Size: A3 Date: 2021-07-02 KiCad E.D.A. kicad 6.0.7-1.fc36

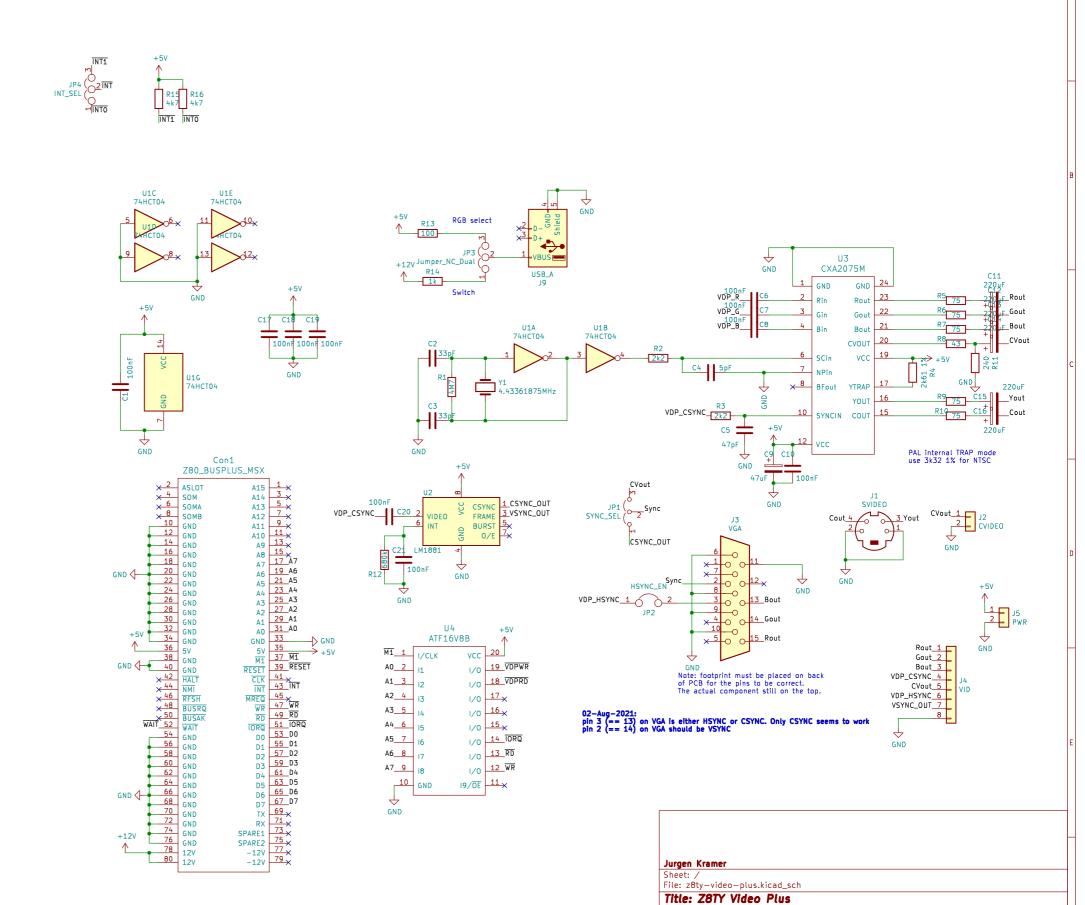
$\overline{\text{FOR NEXT}}$ REVISION/USE: $\overline{\text{VRESET}}$ and $\overline{\text{HRESET}}$ signals need 2k2 / 2k7 pullups. $\overline{\text{VRESET}}$ pin 9 on J8 HRESET pin 8 on J8
